**Revised STAFF REPORT AND RECOMMENDATION  
TO THE DESIGN COMMISSION – APPROVAL WITH  
CONDITIONS**

CASE FILE: LU 15-267105 DZM  
PC # 15-243722  
Hoyt 20 Apartments  
REVIEW BY: Design Commission  
WHEN: April 21, 2016, 1:30pm  
WHERE: 1900 SW Fourth Ave., Room 2500A  
Portland, OR 97201

SOUTH ELEVATION ON NE HOYT ST  
EXHIBIT C-22

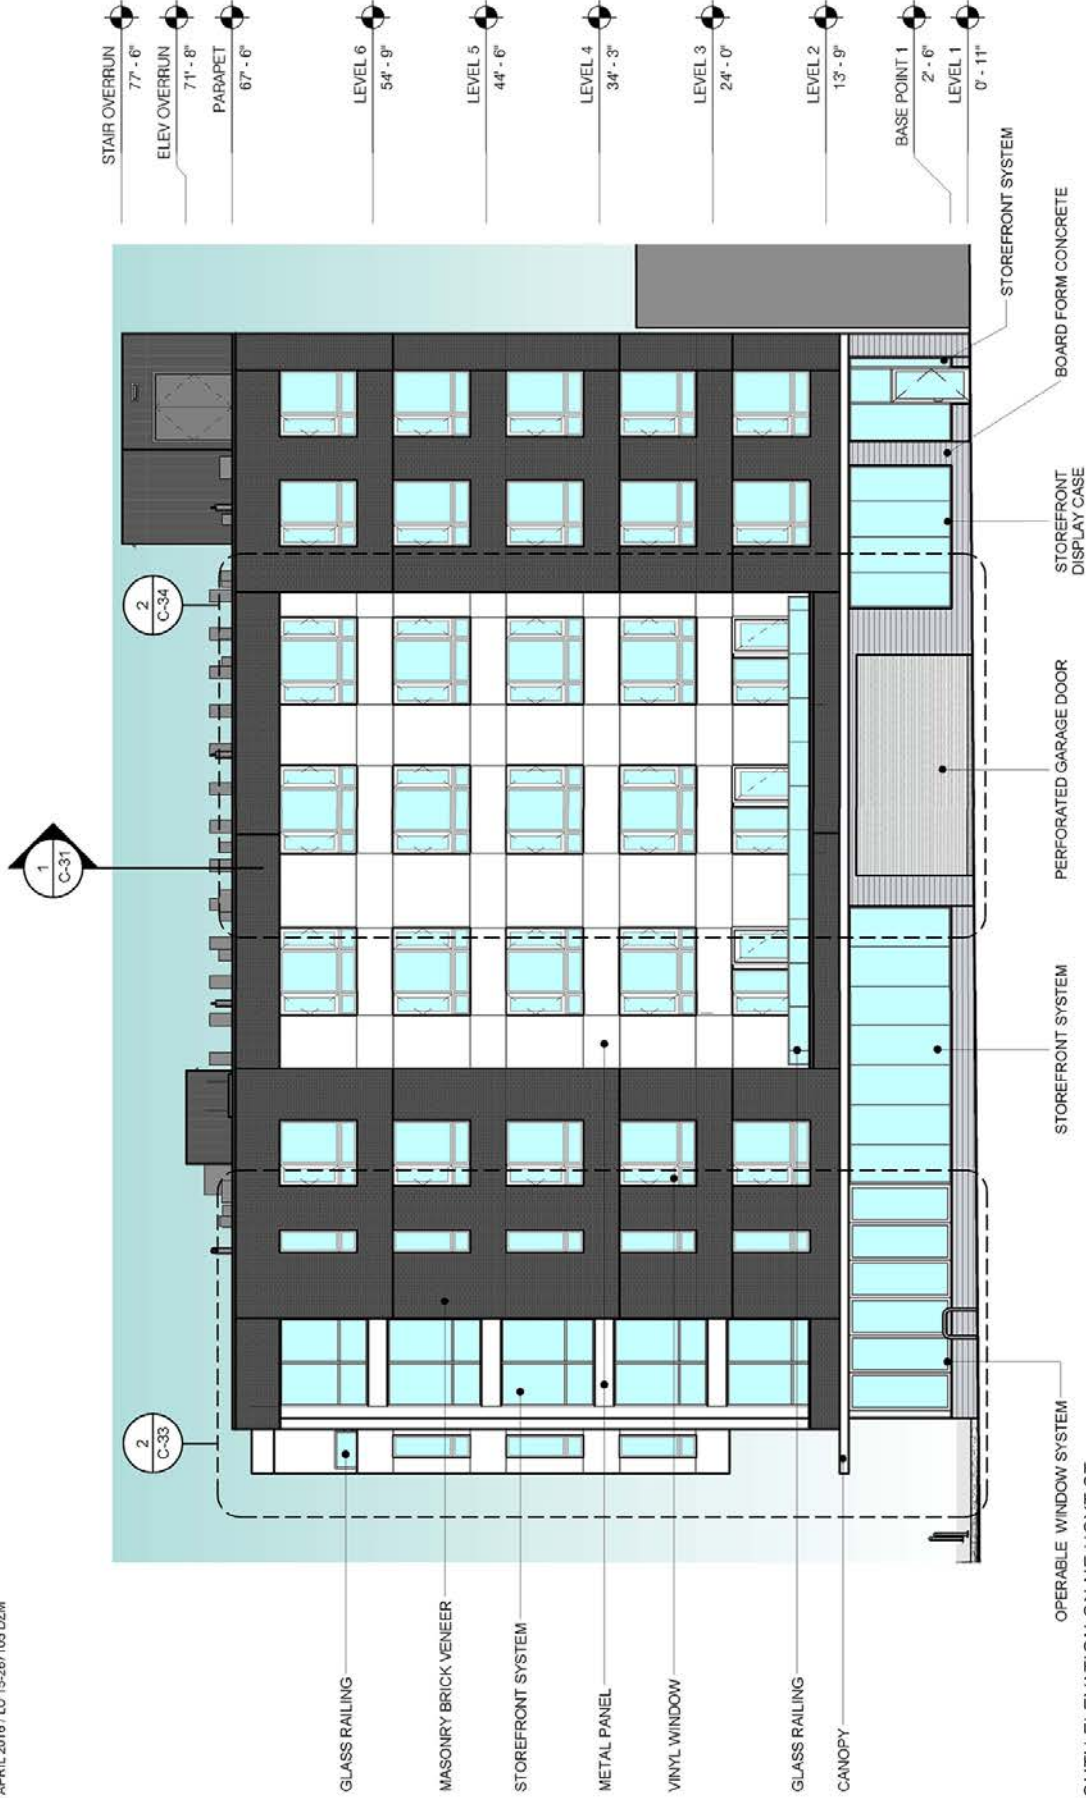
The at-grade parking is well concealed within the building’s interior and lined with active floor area fronting both the NE 20<sup>th</sup> Ave and NE Hoyt St elevations. A common storefront system frames the garage door – active floor area to the west and a display window/egress door to the east. With the addition of the display window, a previous Modification request is no longer required.

With the following changes made in response to Design Commission comments at the March 3, 2016 hearing – *addition of a display window lining the parking frontage facing NE Hoyt St, deeper leasable retail space, addition of a common storefront system facing NE Hoyt St* – the project thoughtfully buffers pedestrians from vehicle areas.

WEST ELEVATION ON NE 20TH AVE  
EXHIBIT C-23

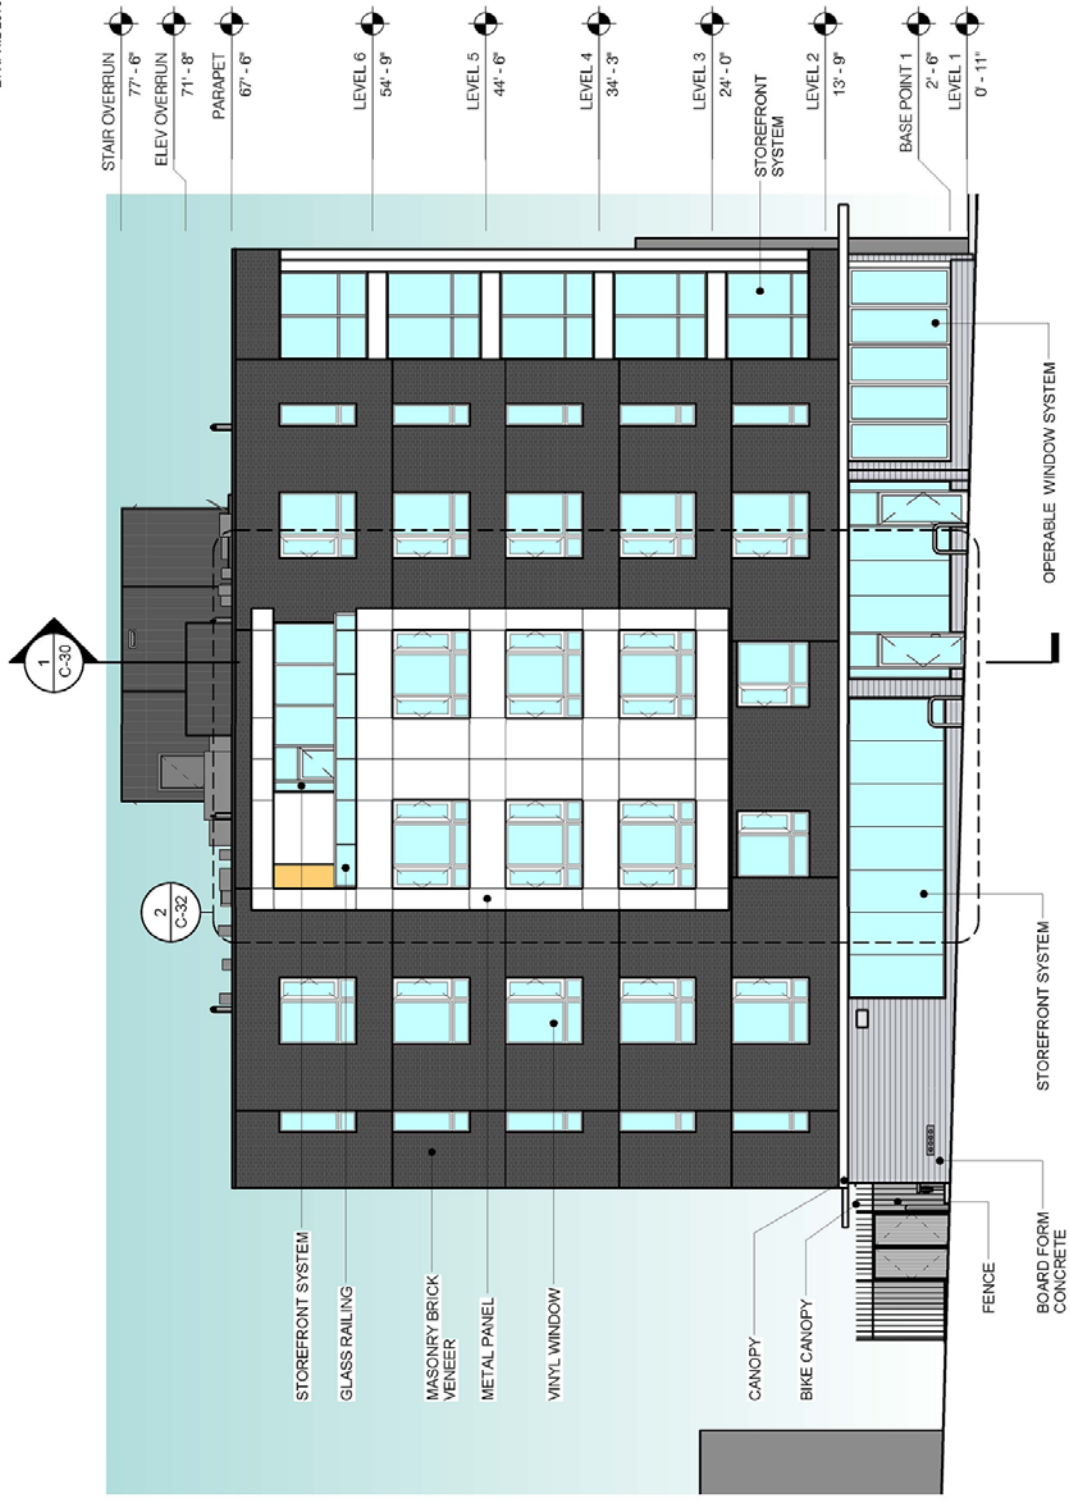
Windows that project into the public right-of-way have a maximum width of 12'. When approved through design review, the width may vary. The proposal includes a 27' wide window projecting into the NE 20<sup>th</sup> Ave public right-of-way at the east elevation near the middle of the building.

**Findings:** The proposed projection is approximately 27' wide. This Criterion is not met but is approvable with (1) compliance with standards C and D, and (2) a favorable recommendation through Design Review. Standards C and D are met.

With regard to Design Review consideration as described above, the Oriel expression works well with the project's overall simplified cube expression, and, as such, reads as contextually relevant contributing to the design's compliance with approval criteria – P1 Plan Area Character, D7 Blending into the Neighborhood, D8 Interest, Quality and Composition. *This Criterion is met.*

*Therefore, Staff recommends approval of this requested exception.*
